Well Name: CARRACAS 14B

Notice of Intent

Type of Action: Plug and Abandonment

Notice of Intent – Plug and Abandonment

Proposed P&A

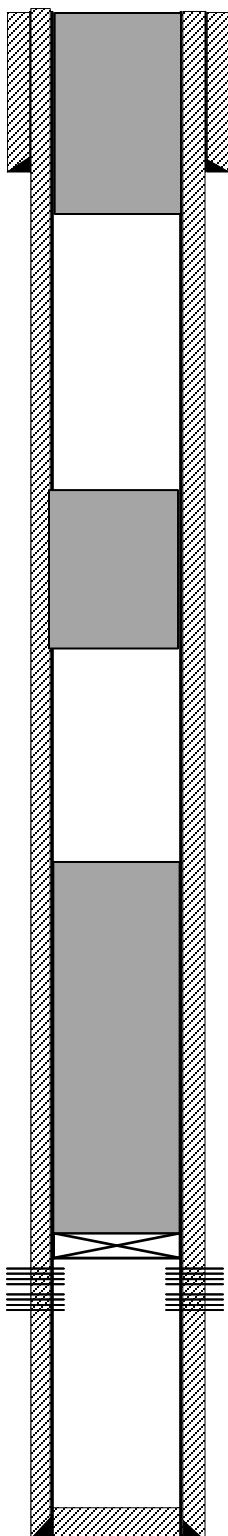
1. Plugging operations authorized are subject to the attached "General Requirements for Permanent Abandonment of Wells on Federal and Indian Lease."
2. The following modifications to your plugging program are to be made:
 - a. No changes to the procedure.
3. **Notification:** Farmington Office is to be notified at least 24 hours before the plugging operations commence at (505) 564 7750.

No available raster logs. Operator selected formation tops are appropriate for the area.
 No changes to the procedure.

You are also required to place cement excesses per 4.2 and 4.4 of the attached General Requirements.
